City of Portland, Maine – Building or Use Permit Application, 289 Congress Street, 04101, Tel: (207) 874-8703, FAX: 874-8716

HISTORIC PRESERVATION
APPLICATION FOR CERTIFICATE OF APPROPRIATENESS

BUILDING PERMIT REPORT

REASON FOR PERMIT: Replace back porch -

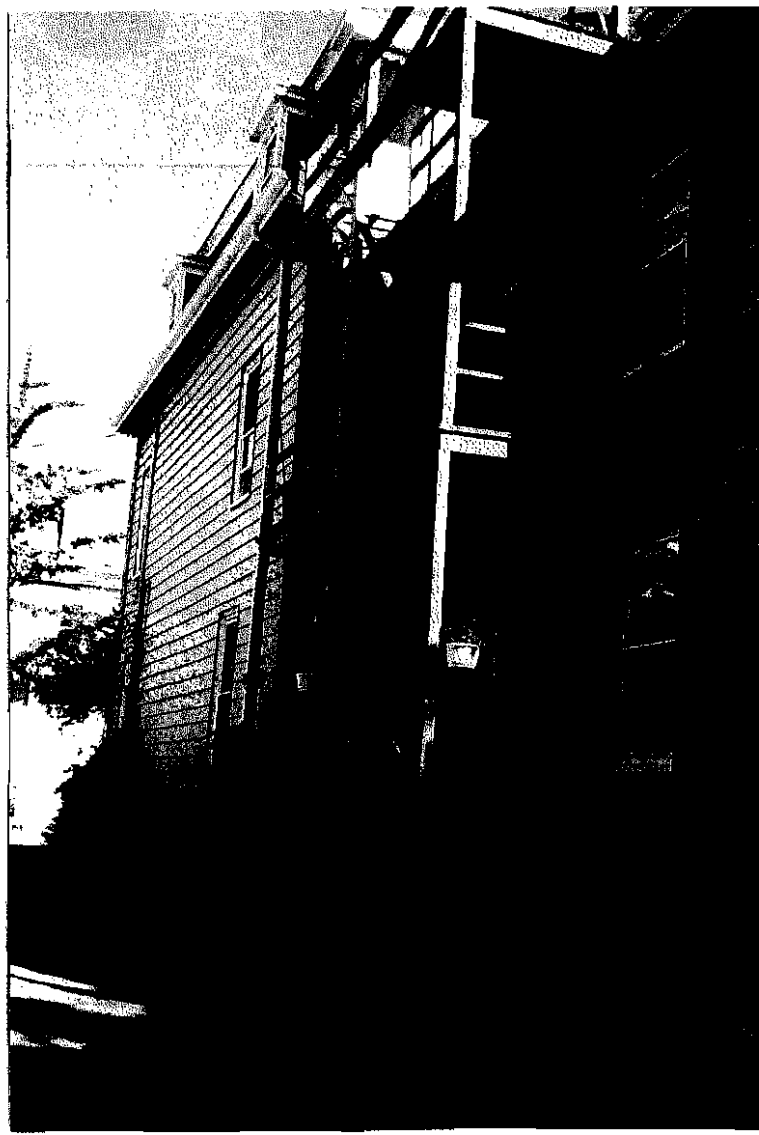
CONDITION(S) OF APPROVAL

This permit is being issued with the understanding that the following conditions shall be met: *1, *2, *11, *13,
*29, *32, *36, *37, #31, #38, 17, 18

10. Sound transmission control in residential building shall be done in accordance with Chapter 12, Section 1214.0 of the City's Building Code.
- *11. Guardrails & Handrails: A guardrail system is a system of building components located near the open sides of elevated walking surfaces for the purpose of minimizing the possibility of an accidental fall from the walking surface to the lower level. Minimum height all Use Groups 42". In occupancies in Use Group A,B,H-4, I-1, I-2, M and R and public garages and open parking structures, open guards shall have balusters or be of solid material such that a sphere with a diameter of 4" cannot pass through any opening. Guards shall not have an ornamental pattern that would provide a ladder effect. (Handrails shall be a minimum of 34" but not more than 38". Use Group R-3 shall not be less than 30", but not more than 38"). Handrail grip size shall have a circular cross section with an outside diameter of at least $1\frac{1}{2}$ " and not greater than 2". (Sections 1021 & 1022.0). Handrails shall be on both sides of stairway. (Section 1014.7)

12. Headroom in habitable space is a minimum of 7'6". (Section 1204.0)
- *13. Stair construction in Use Group R-3 & R-4 is a minimum of 10" tread and 7 $\frac{1}{4}$ " maximum rise. All other Use Group minimum 11" tread, 7" maximum rise. (Section 1014.0)

* 37. Fasters shall be used between Columns Foundation, and Columns and decking.
